UNITED STATES PATENT AND TRADEMARK OFFICE

Office Action Summary	Application No. 10/581,415	Applicant(s) MAIER ET AL.	
	Examiner MACADE BROWN	Art Unit 3753

DETAILED ACTION

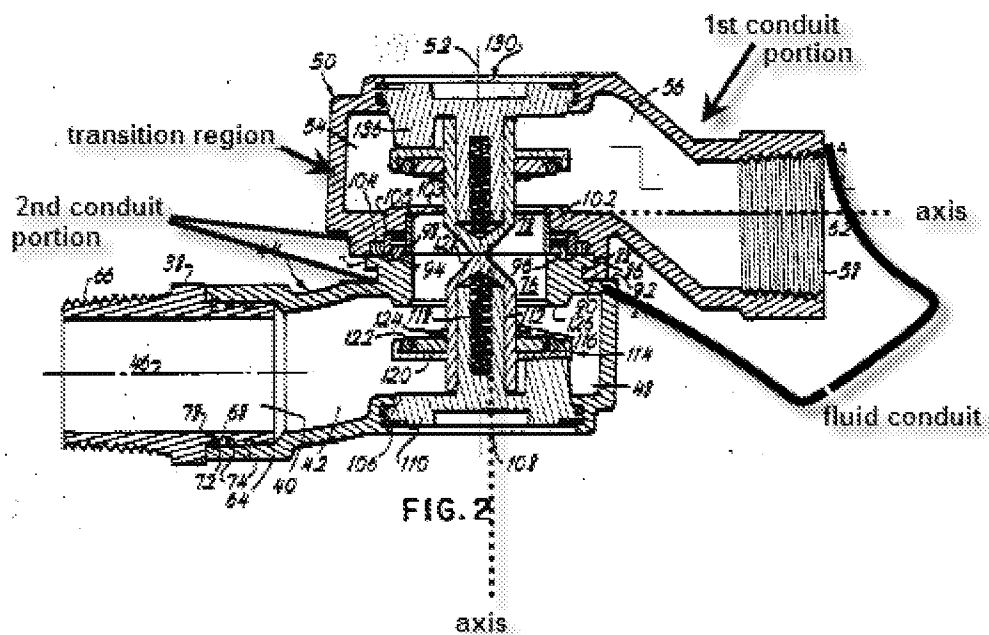
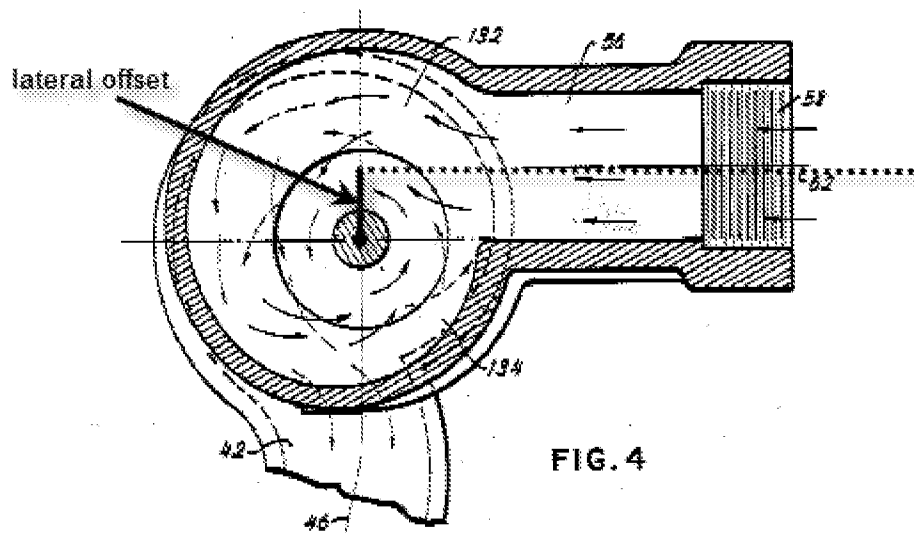
Regarding claims 10-12, and 27, Nitzberg et al. teaches a valve element 114 (fig. 2) disposed in a valve chamber 48 and a fluid conduit (see below in fig. 2) adjoining the valve chamber 48 on the upstream side of the valve chamber 48, the valve element 114 alternatively opening and closing the fluid conduit on the upstream side of the valve chamber 48 (the valve is initially open and closes upon its removal from the conduit),

the conduit has a substantially constant width and is capable of producing a swirl-type rotation about the longitudinal axis of the fluid conduit being impressed on the fluid stream that flows toward the valve chamber 48, without a constriction of the fluid stream being produced by the conduit in the production of the swirl-type rotation of the fluid; the conduit includes a first conduit portion and second conduit portion (see fig. 2 below) adjoining the first conduit portion, the longitudinal axes of the first and second conduit portions being at an angle less than 180 degrees to one another (see fig. 2 below), and the longitudinal axis for the first conduit portion being laterally offset from the longitudinal axis of the second conduit portion (see fig. 4 below); the longitudinal axes of the first and second conduit portions are at least approximately at a right angle to one another (see fig. 2 below); the first conduit portion extends no more than a very small distance past the second conduit portion.

Regarding claims 13-15, 21, and 25, Nitzberg et al. teaches a transition region 50 between the first conduit portion and the second conduit portion; wherein the transition region includes a wall that is curved from the first conduit portion to the second conduit portion (see fig. 2 above), but fails to disclose a ball as the valve element, and the transition region being machined by means of electrochemical removal of material.

Regarding claims 16, 17, 22 and 26, Nitzberg et al teaches the first and second conduit portion, in cross section, have approximately the same radius; the transition region includes a wall that is curved from the first conduit portion to the second conduit portion (see fig. 2 above), but fails to disclose the lateral offset of the longitudinal axes is greater than the radius; the transition region being machined by means of electrochemical removal of material.

Nitzberg et al. teaches a fluid conduit (see fig. 2 above) has a substantially constant width and is capable of producing a swirl-type rotation about the longitudinal axis of the fluid conduit being impressed on the fluid stream that flows toward the valve chamber 48, and the longitudinal axis of the first conduit portion being laterally offset from the longitudinal axis of the second conduit portion, to permit the fuel to flow at high flow rates in a laminar fashion through the coupling.

FIG. 2

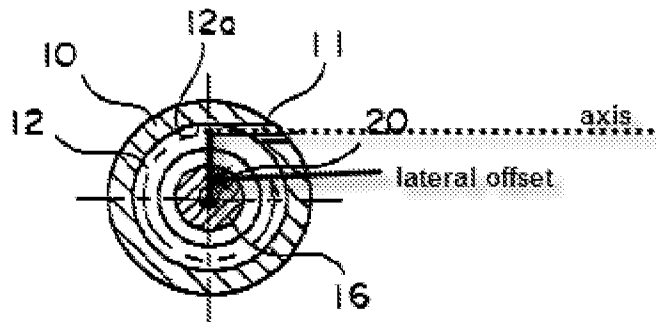
Urya et al. teaches a first and second conduit portions 11, 20 (figs. 1 and 2) having at least approximately the same radius, the lateral offset of the longitudinal axes is greater than the radius (see fig. 2 below), to reduce the amount of fluid colliding with working fluid newly flowing in through the inflow conduit 11, to stabilize the whirl flow of the fluid entering the flow path 12.

It would have been obvious to one of ordinary skill in the art, at the time of invention, to employ in Nitzberg et al. a lateral offset of the longitudinal axes being greater than the radius, as taught by Urya et al, for the purpose of stabilizing the whirl flow of the fluid entering the flow path conduit.

having at least approximately the same radius, the lateral offset of the longitudinal axes is greater than the radius (see fig. 2 above), to reduce the amount of fluid colliding with working fluid newly flowing in through the inflow conduit 11, to stabilize the whirl flow of the fluid entering the flow path 12.

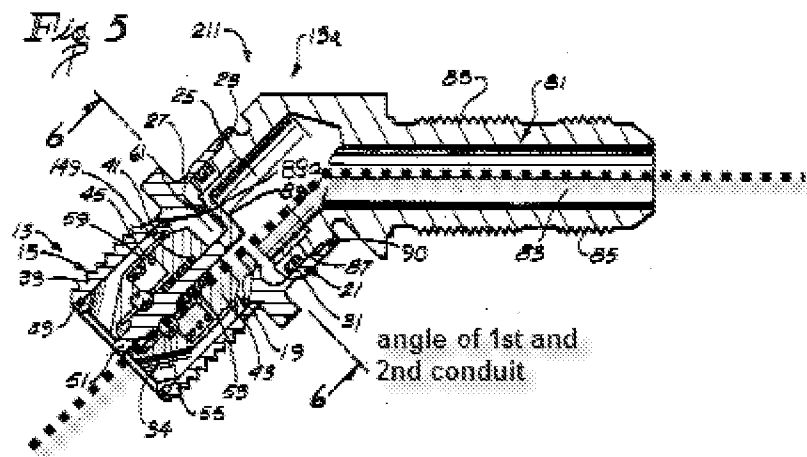
Regarding claims 19, 20, 23, and 24, Nitzberg et al. teaches essentially all claimed features, but fails to disclose the transition region being machined by means of electrochemical removal of material.

The patentability of a product does not depend on its method of production, i.e. electrochemical removal. If the product in the product-by process claim is the same as or obvious from a product of the prior art, the claim is unpatentable even though the prior product was made by a different process. In re Thorpe, 777 F.2d 695, 698, 227 USPQ 964, 966 (Fed. Cir. 1985).
